**BROWNS FERRY NUCLEAR PLANT (BFN) - UNITS 2 AND 3 - TECHNICAL SPECIFICATIONS (TS) CHANGE TS-418 - RESPONSE TO REQUEST FOR ADDITIONAL INFORMATION SPSB-A.11 REGARDING EXTENDED POWER UPDATE - CREDIT FOR NET POSITIVE SUCTION HEAD (TAC NOS. MC3743 AND MC3744)**

ENCLOSURE 1  
TENNESSEE VALLEY AUTHORITY (TVA)  
BROWNS FERRY NUCLEAR PLANT (BFN) UNITS 2 AND 3  
RESPONSE TO NRC REQUEST FOR ADDITIONAL INFORMATION  
REGARDING PROPOSED TECHNICAL SPECIFICATION (TS) TS-418  
EXTENDED POWER UPRATE - CREDIT FOR NET POSITIVE SUCTION HEAD

NRC REQUEST SPSB-A.11

**FIGURE 1**  
**NET POSITIVE SUCTION HEAD REQUIREMENTS FOR DESIGN BASIS LOSS OF COOLANT ACCIDENT – SHORT TERM**

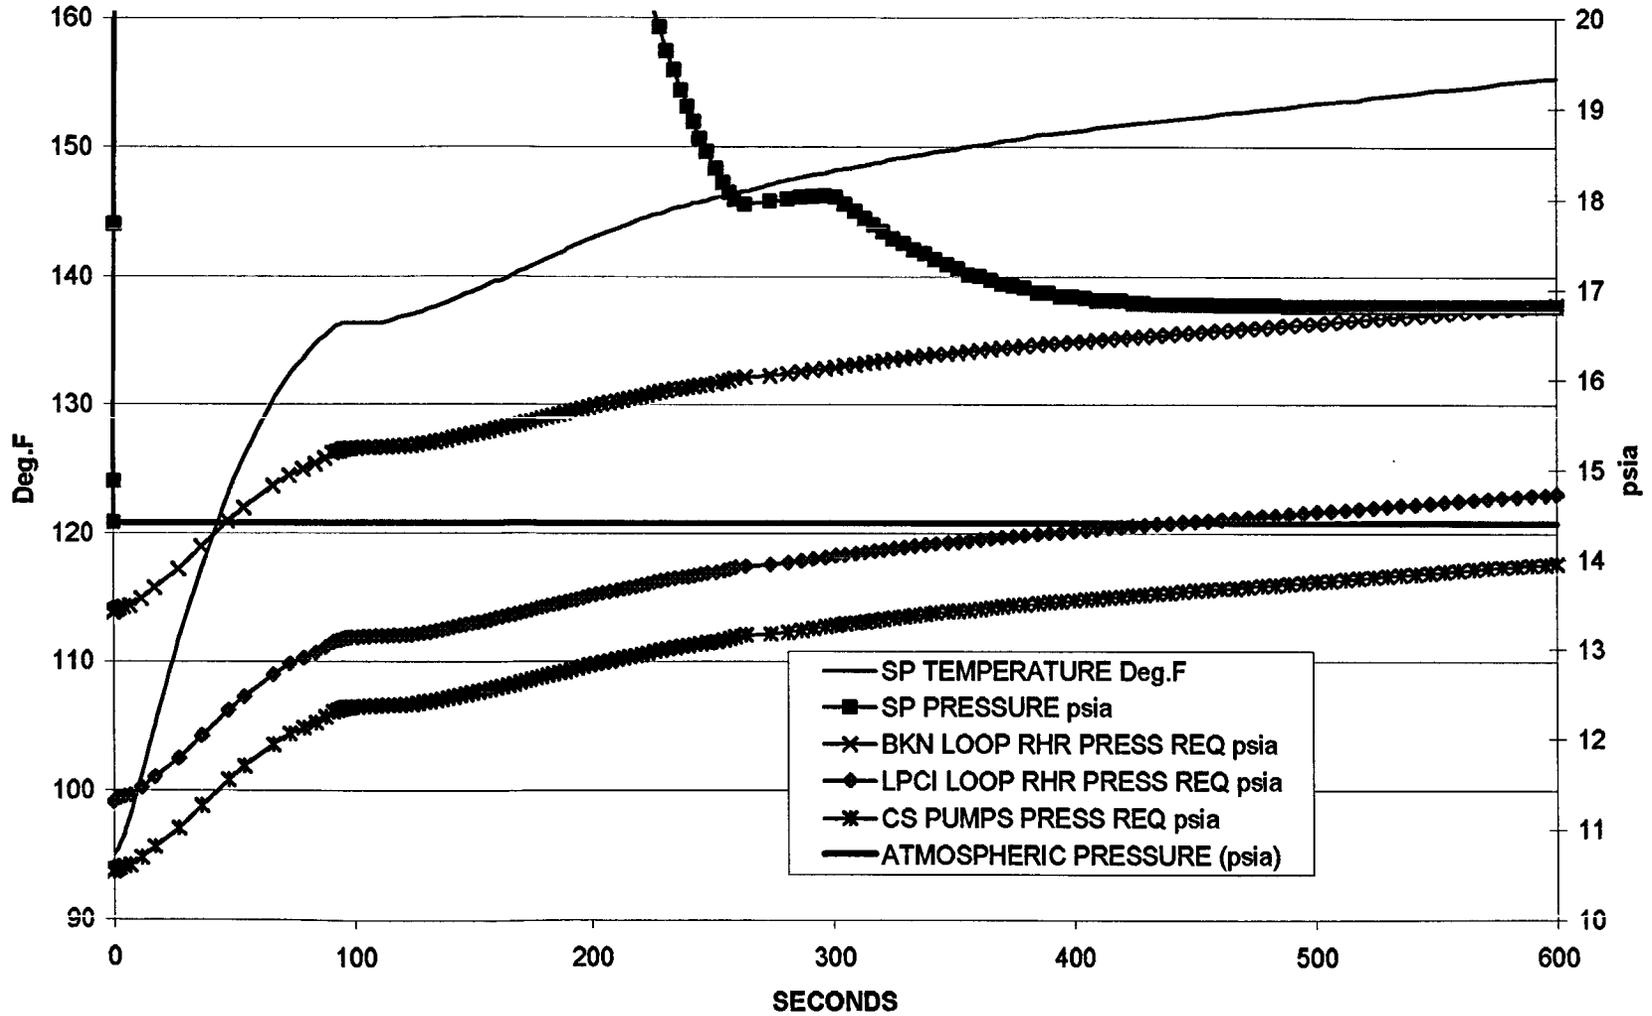
The bounding design basis event for determining NPSH margin is a double ended recirculation discharge line break. This event results in maximum suppression pool temperature and maximum total pump flow. The discharge line break is chosen because the low system resistance on the broken line produces the most limiting flow and NPSH for two RHR pumps which are assumed to be pumping into the broken line inside containment. At the beginning of the event, four RHR pumps and four Core Spray pumps start automatically and align to inject to the Reactor Pressure Vessel (RPV). Two RHR pumps inject to the RPV at 10,000 gpm each, two RHR pumps inject through the broken line into the containment at 11,000 gpm each (greater than design flow), and four Core Spray pumps inject to the RPV at 3,125 gpm each. This mode of operation is assumed for 10 minutes consistent with not crediting operator action for 10 minutes. ECCS strainers are assumed to accumulate the maximum equilibrium debris load. During this time suppression pool temperature reaches 155.4°F and only the RHR pumps require credit for COP in order to have sufficient NPSH margin as shown in Figure 1.

COP was lost. Core Spray pumps do not require COP in the short-term (Refer to Figure 1). BFN Core Spray pumps are Sulzer-Bingham model 12x16x14.5 CVDS. Assuming no credit for COP, the Core Spray pumps used for long-term core cooling (>10 minutes) would be expected to operate between 27 feet and 22.6 feet of NPSH verses 27 feet used in NPSH calculations for approximately 13.4 hours as Suppression Pool temperature peaks above 175.8°F during the LOCA. In the unlikely event they become degraded, there is a reasonable likelihood that the affected pumps would still be able to function. In addition, only one of the two Core Spray loops is required to be operated for adequate core cooling and the non-operating Core Spray loop would be available to operators if the operating loop failed after some time period. RHR pumps would also be available in the LPCI mode for core cooling in conjunction with their suppression pool cooling function should all Core Spray pumps become unavailable. COP is not required for RHR pumps in the long-term scenario. Therefore in the unlikely event that COP was lost in the long-term LOCA, the decay heat removal and core cooling functions would be maintained.

**FIGURE 2**  
**NET POSITIVE SUCTION HEAD REQUIREMENTS FOR DESIGN BASIS LOSS OF COOLANT ACCIDENT – LONG TERM**

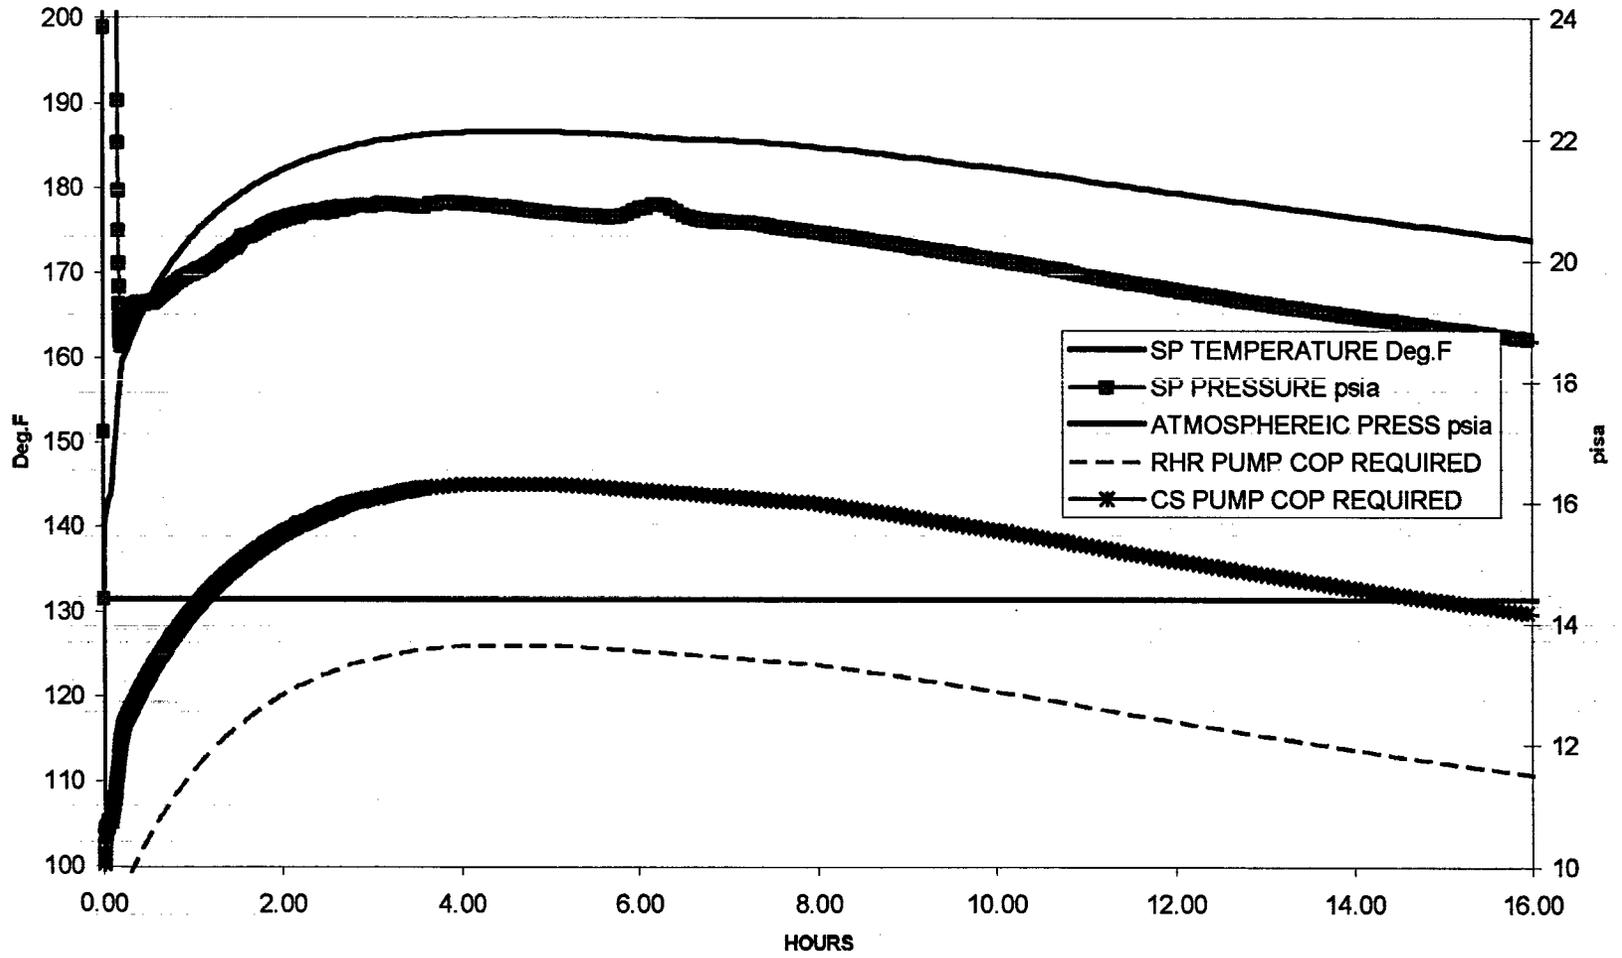
At 10 minutes, operator action is assumed which places the minimum complement of ECCS pumps into modes required for long term cooling. Two Core Spray pumps (one loop) at design flow of 3,125 gpm each are assumed for core cooling, and two RHR pumps in one loop in containment cooling mode at 6,500 gpm each are assumed for pool cooling. Containment spray mode of containment cooling is chosen to minimize available containment pressure. Only two of four RHR pumps are assumed for pool cooling due to single failure considerations. ECCS strainers are assumed to accumulate the maximum equilibrium debris load. During this time suppression pool temperature reaches 187.4°F and only the

two Core Spray pumps require credit for COP in order to have sufficient NPSH margin as shown in Figure 2.

**FIGURE 3**  
**CONTAINMENT OVERPRESSURE SENSITIVITY TO RESIDUAL HEAT REMOVAL SERVICE WATER (RHRSW) TEMPERATURE AND**  
**NET POSITIVE SUCTION HEAD SENSITIVITY TO RHRSW TEMPERATURE**

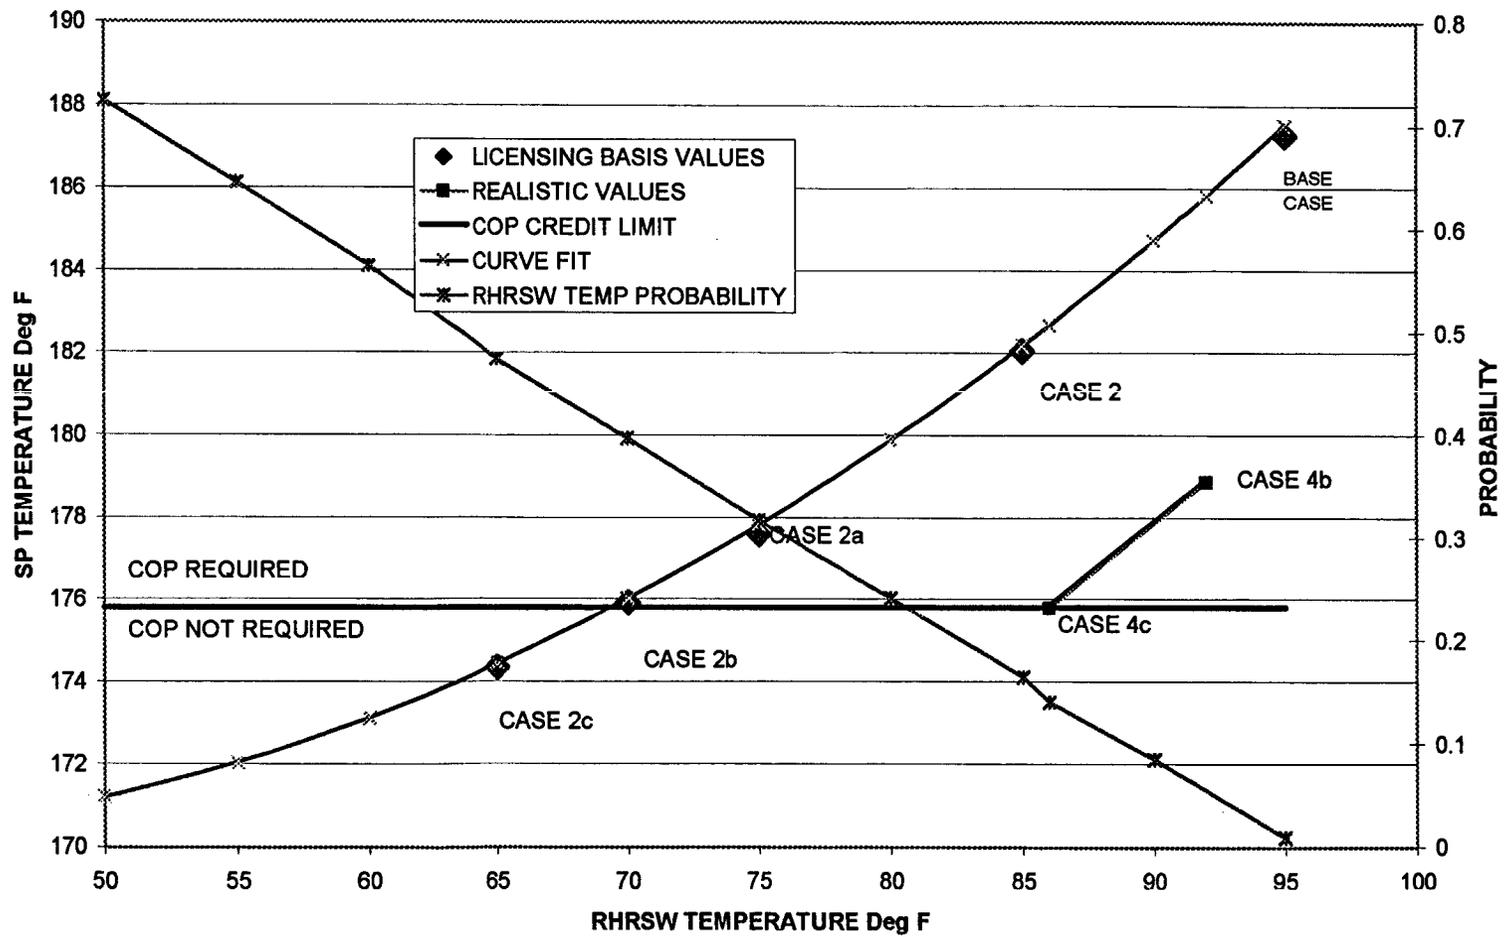
Suppression pool temperature response was examined as a function of RHRSW temperature which is a seasonal variable. Figure 3 shows Suppression Pool temperature as a function of RHRSW temperature using both licensing basis input values and realistic values. These analyses show that COP is not required for RHRSW temperatures 70°F or below assuming all design basis inputs and 86°F using realistic inputs. The probability of exceeding 70°F is 3.97E-1 and for 86°F is 1.40E-1.
